SUNDRY NOTICES AND REPORTS ON WELLS
Do not use this form for proposals to drill or to re-enter an abandoned well. Use form 3160-3 (APD) for such proposals.

MKL-~~788~~ #14

In reference to letter dated January 14, 2004, NMSF-079162 (WC), 3162.3-2 (7100) Dominion plans to recompleate the referenced well as follows:

MKL 14-8

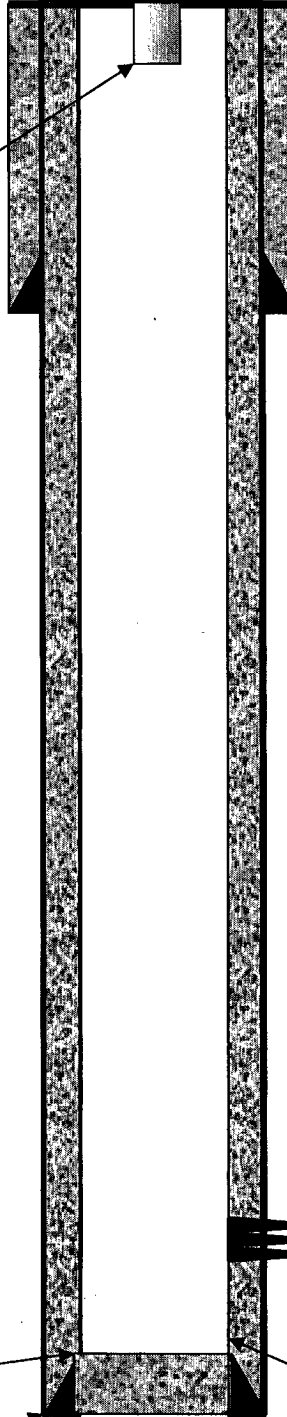
1. Perforate (additional perfs) the fruitland coal f/2018 - 2103.
2. Frac, flow back & test
3. Put well on production.

See attached before and after schematics. Depending on rig availability, Dominion plans to complete this work by April 1, 2004.

Proposed

2018-20'

2022-26'

2031-33

2044-52'

2075-80'

2090-94'

2101-3'
